**National Committee on Uniform Traffic Control Devices  
RWSTC RECOMMENDATION TO COUNCIL 6-21-07**

**TECHNICAL COMMITTEE : Regulatory/Warning Sign TC**

**TOPIC:** Section 2A.18 and Section 6F.03 **MOUNTING HEIGHT OF SIGNS**

Figure 2A-1. Examples of Heights and Lateral Locations of Signs for Typical Installations

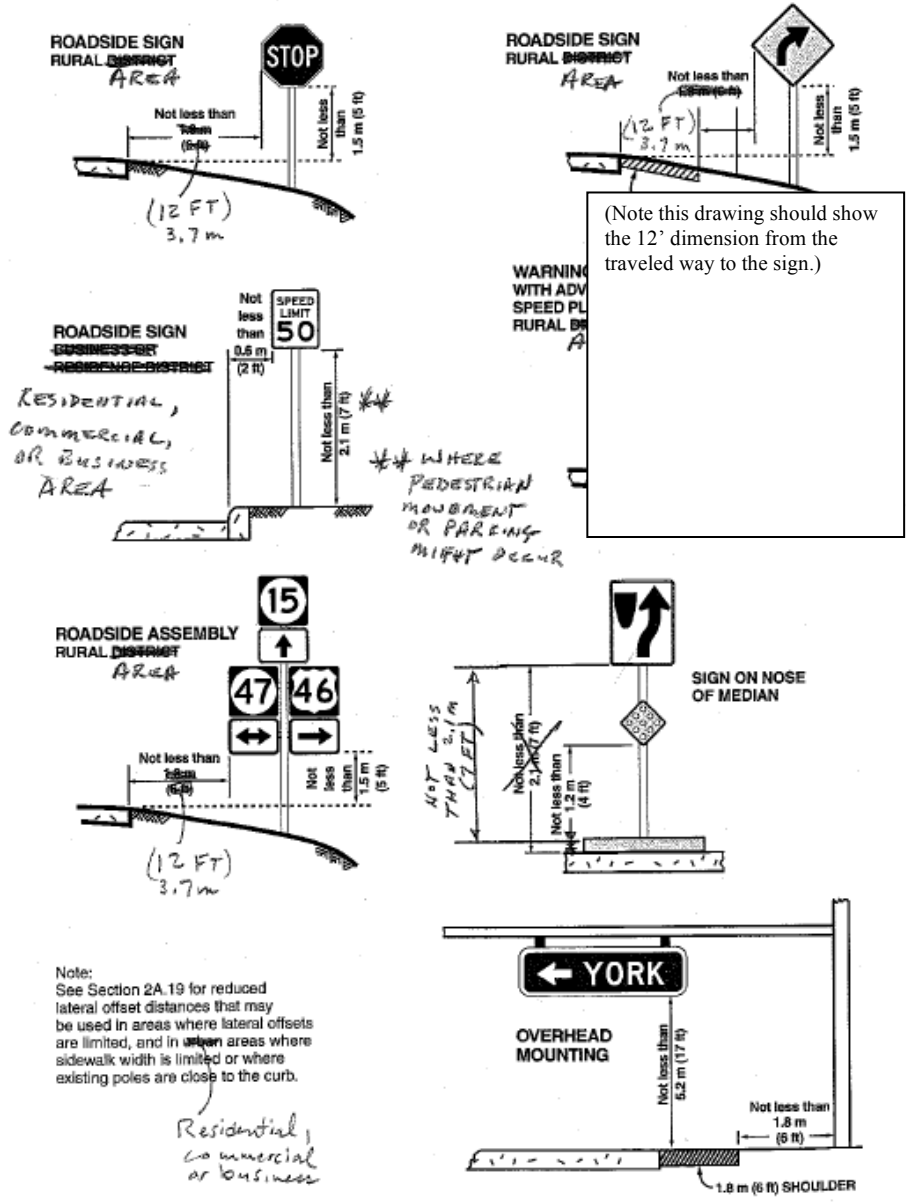
The standard statement needs to be clear that it is vertical height even though Fig 2A-1 depicts it that way.

Figure 2A-1 indicates a 7' mounting height measured from the top of the curb in one detail and measured from the roadway surface where used in the median.

4. Change 2A.18 so it is clear that this is vertical dimension.
5. Change Figure 2A-1 to indicate 7’ clearance from the top of curb where pedestrians might be. Change Figure 2A-1 headings to read ROADSIDE SIGN RURAL DISTRICT to read ROADSIDE SIGN RURAL AREA. Change the sign on median nose to indicate vertical measurement is from top of curb to bottom of sign.

Change Figure 2A-1 to indicate 7' clearance from the top of curb where pedestrian movement or parking might occur. Change the sign on the median nose to indicate vertical measurement is from top of curb to bottom of sign. Change District to Area.

Figure 2H-3. Height and Lateral Position of Signs Located Within Recreational and Cultural Interest Areas

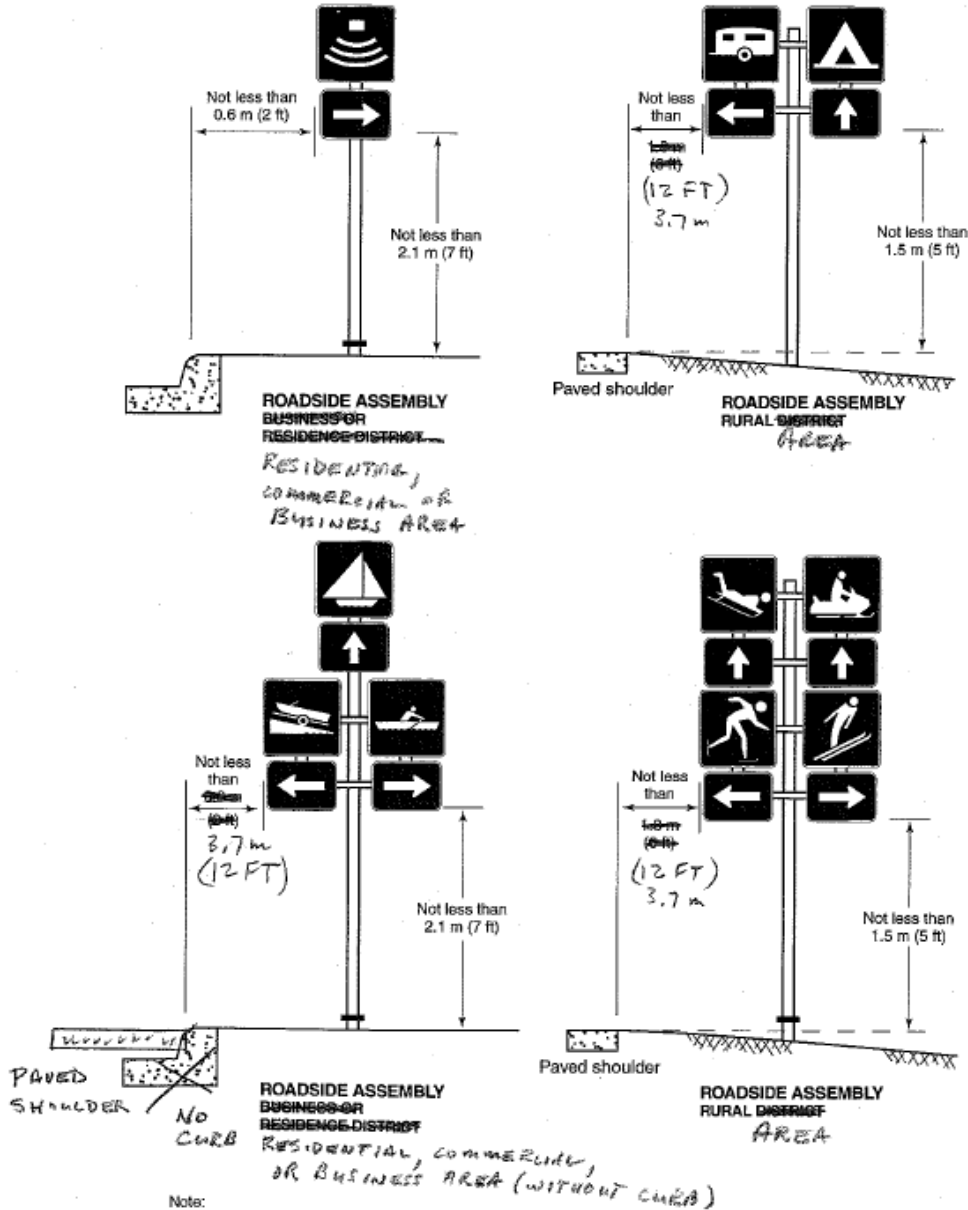
6. Change Figure 2H-3 headings from RURAL DISTRICT to read RURAL AREA on the details. Remove the curb and gutter from the lower left detail of Figure 2H-3 to illustrate an urban detail without curb and gutter. **The G/MI Technical committee approved this change on 1-19-06**

Change Figure 2H-3 by omitting the curb in the bottom left detail to illustrate residential, commercial, or business area without curb. Change District to Area.

Figure 6F-1. Height and Lateral Location of Signs—Typical Installations

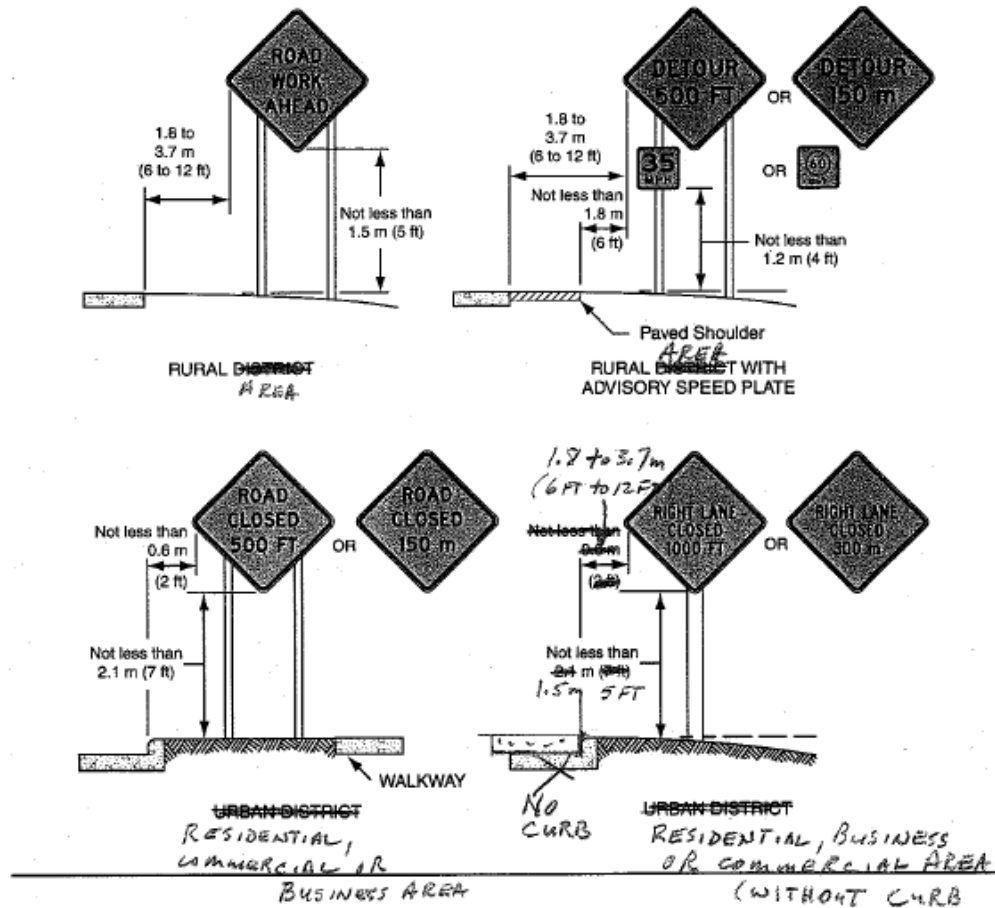
1. Section 2A.18 under the **Standard** paragraph uses the term rural district. Section 6F.03 uses the term rural areas in the text and districts in the Figure. Section 2A.18 needs to be changed to rural areas. Figure 6F-1 needs to be changed to

7. Change Figure 6F-1 headings from RURAL DISTRICT to read RURAL AREA. Change the detail on the left from URBAN DISTRICT to RESIDENTIAL, COMMERCIAL, OR BUSINESS AREA. Change the detail on the right from URBAN DISTRICT to RESIDENTIAL, COMMERCIAL, OR BUSINESS AREA WITHOUT WALKWAY, and delete the curb in order to match the text in 6F.03. **The Temporary Traffic Control Technical committee approved this change on 1-19-06.**

### **Figure 6F-1 – Change “District” to “Area”**

Change Figure 6F-1 headings from District to Area and change the detail in the bottom right to illustrate residential, commercial, or business area without curb.

Figure 2A-2. Examples of Locations for Some Typical Signs at Intersections

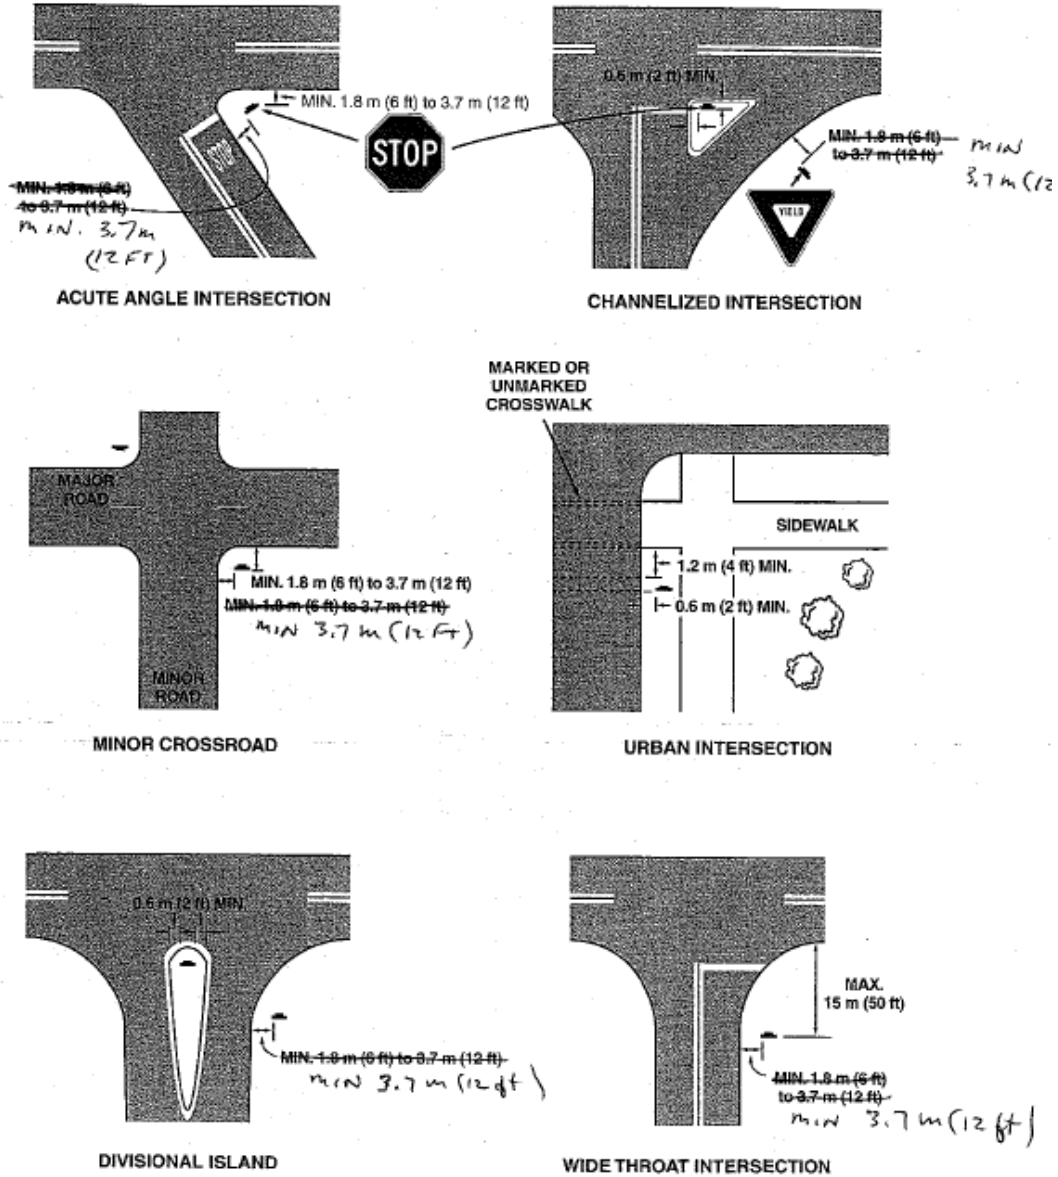
Note: Figures 2A-1 and 2H-3 revised to 12' lateral offset. Figure 2A-2 added to match Figure 2A-1 lateral offset. No change to Figure 6F-1 from that sent to sponsors.
